**Re: Appeal of Planning Commission Approval of AG Forest Wood Processing
Bioenergy Facility Major Use Permit UP 23-05, Initial Study/Mitigated
Negative Declaration IS 23-10**

At your request, I have prepared this Report in response to the County of Lake's IS/MND for the Ag Forest Wood Processing Bioenergy Project ("Project"). My qualifications are attached hereto as "Attachment 1". This report shows that the Project's noise impacts are potentially significant under the California Environmental Quality Act, Pub. Res. Code § 21000 *et seq.*, ("CEQA") and will exceed maximum permissible noise standards set by the County of Lake ("County").

FIGURE B - DISTANCES FROM NOISE SENSITIVE RECEPTORS TO CONSTRUCTION NOISE

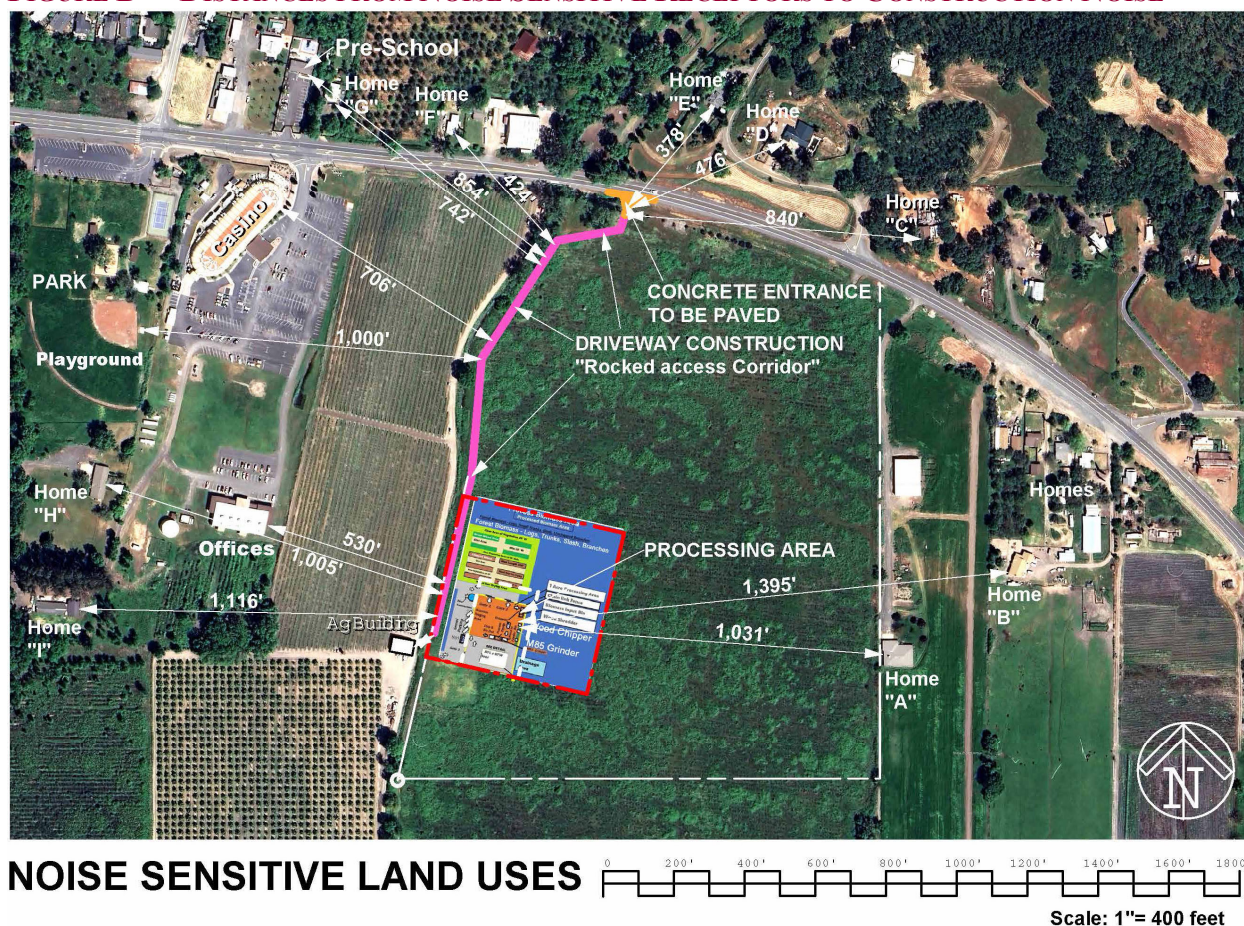
DRIVEWAY CONSTRUCTION COULD GENERATE NOISE LEVELS INSIDE SOME NEIGHBORING HOMES THAT EXCEED THE COUNTY'S GENERAL PLAN 45 dBA CNEL INTERIOR NOISE LIMIT.

With an exterior noise level of 71.6 dBA CNEL at Homes "H" and "I's windows, and with a typical attenuation (reduction) factor of 20 dBA due to noise passing through the walls and roof of a home with its windows closed, the interior noise level indoors would be as much **51.6 dBA CNEL**.¹⁹ That interior noise level due to Project construction would exceed the Building Code standards and the County General Plan's maximum allowable **45 dBA CNEL** interior noise limit. Even with a slight reduction in noise levels due to atmospheric attenuation of about 1 dB at these distances, the interior noise levels would still exceed the County's maximum standards. Therefore this Project's construction noise impacts to the interior noise levels would be significant at some homes.

FIGURE C - DISTANCES FROM NOISE SENSITIVE RECEPTORS TO WOOD CHIPPER NOISE

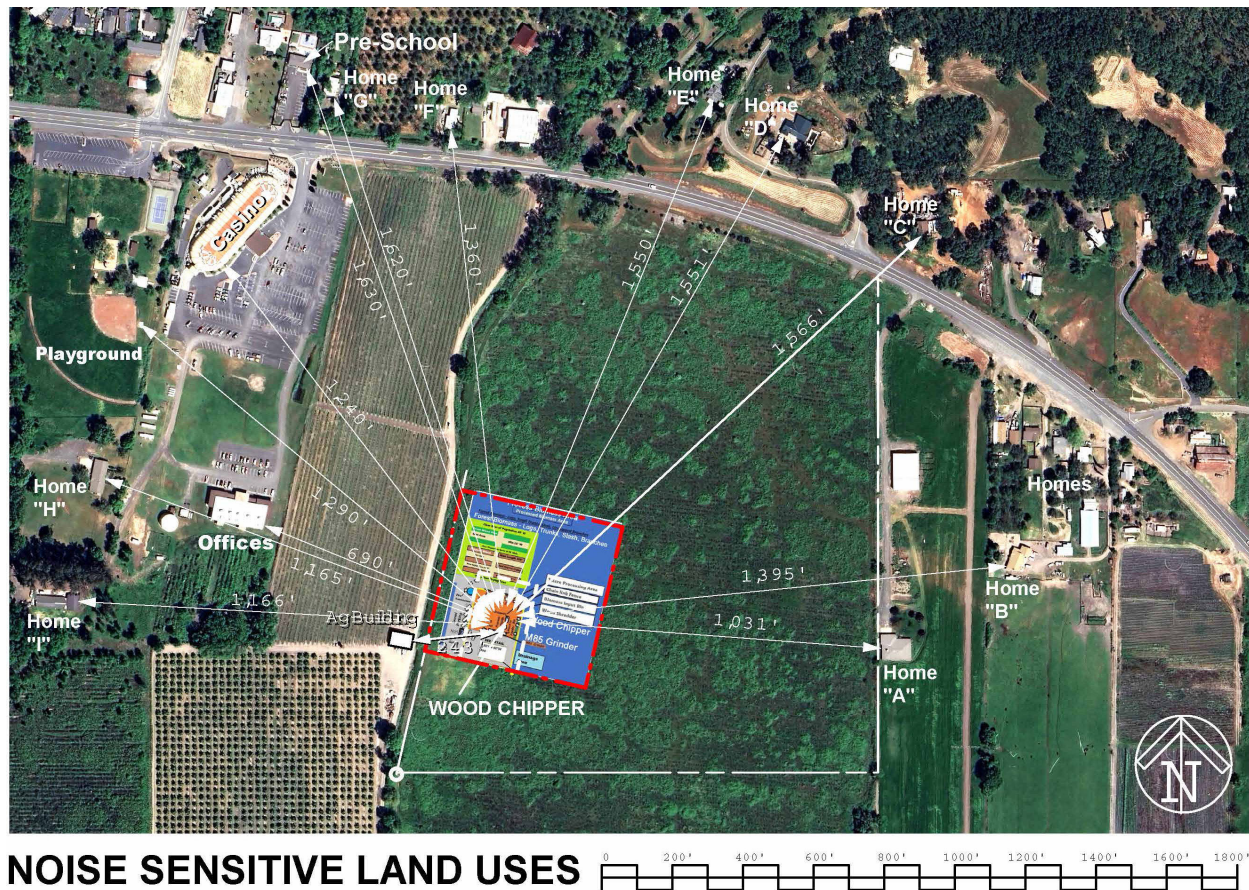
This Project would use a wood chipper to grind up logs and small tree trunks.²⁶ Wood chippers play a crucial role in processing smaller diameter wood, branches, and other woody debris into smaller, more uniform chips. Wood chipper noise levels have been rated by other counties up to 89 dBA L_{max} at 50 feet.²⁷ That accordingly is a noise level also used in this Report. The applicants have not agreed to only use a quieter wood chipper. The Planning Commission enacted no conditions of approval, no mitigation and no other requirement to use a less noisy wood chipper. With few effective noise barriers proposed to remain at all times surrounding the wood chipper, the following calculated noise levels at nearby homes are estimated.

⁴⁹ See Figure C for that distance of 1,290 feet from the Project's central processing area with the chipper to the Park.

FIGURE A - DISTANCES FROM PROJECT OPERATION TO NOISE SENSITIVE RECEPTORS

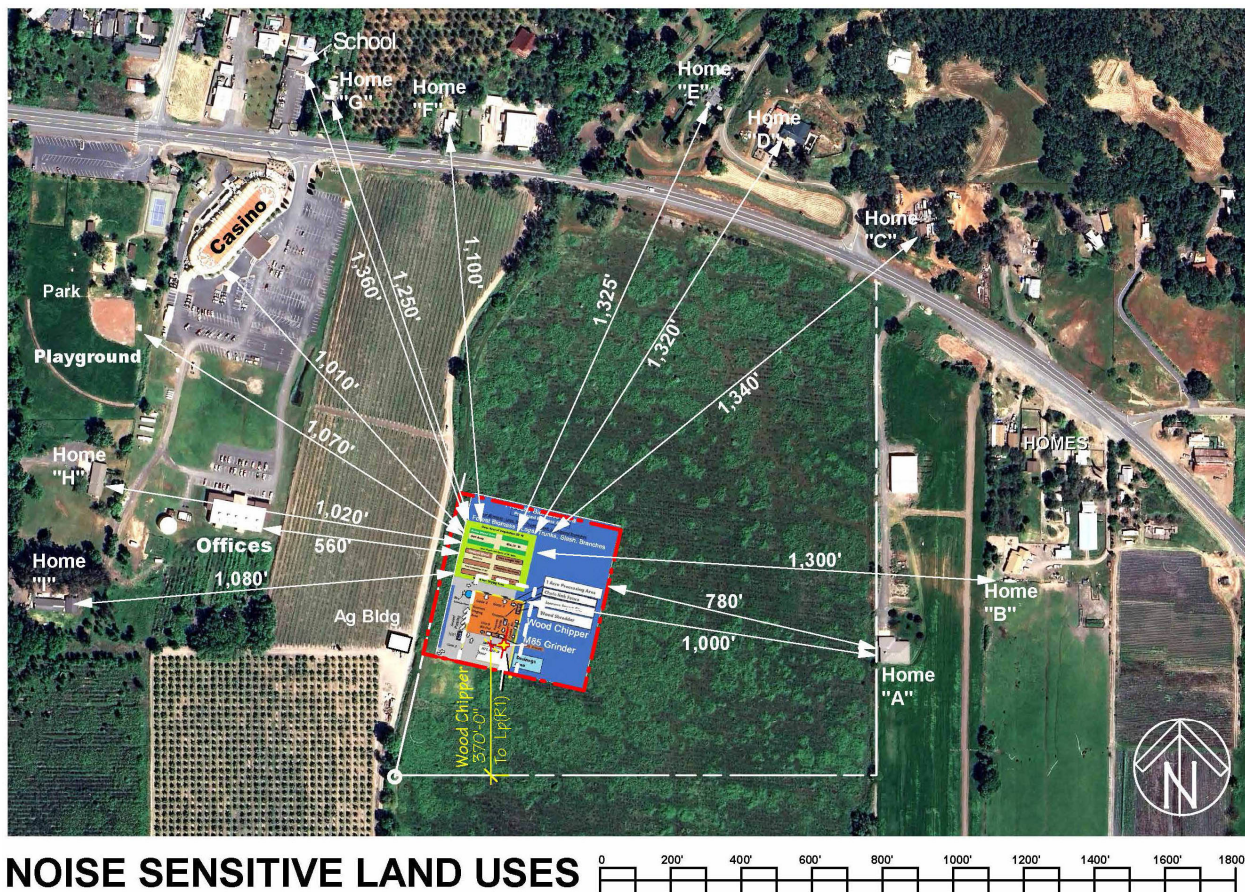
- F. **Operation noise** levels may exceed the County's noise standards at the office building with tribal offices located about 690 feet to the west of major Project noise sources. At that close distance, the noise level from Project operations would cause a significant noise impact. Yet the IS/MND never analyzed that serious risk to those office users that could harm their business work and personal health. (See p. 32 and Figure A.)

- G. **Operation noise** levels at the Running Creek Casino located about 1,010 feet to the northwest of major Project noise sources may also exceed the County's noise standards for commercial uses. (See p. 33 and Figure A.) The Zoning Ordinance allows up to 60 dBA $L_{eq-1 \text{ hr}}$, but Project operation noise at the casino could be as high as about 68.2 dBA $L_{eq-1 \text{ hr}}$. (See p. 33.)

On the following page, a map ([Figure A](#)) is repeated for convenience to show distances from various loud Project operations to each sensitive receptor listed in this report.

During preparation of this Noise Impacts Report, we were able to uncover the IS/MND's mapping inadequacy by using precise CAD drafting software that County officials and the general public probably do not have access to. But the public should not have such critical mapping information be hidden from them such that they would need specialized software and skills to unravel.
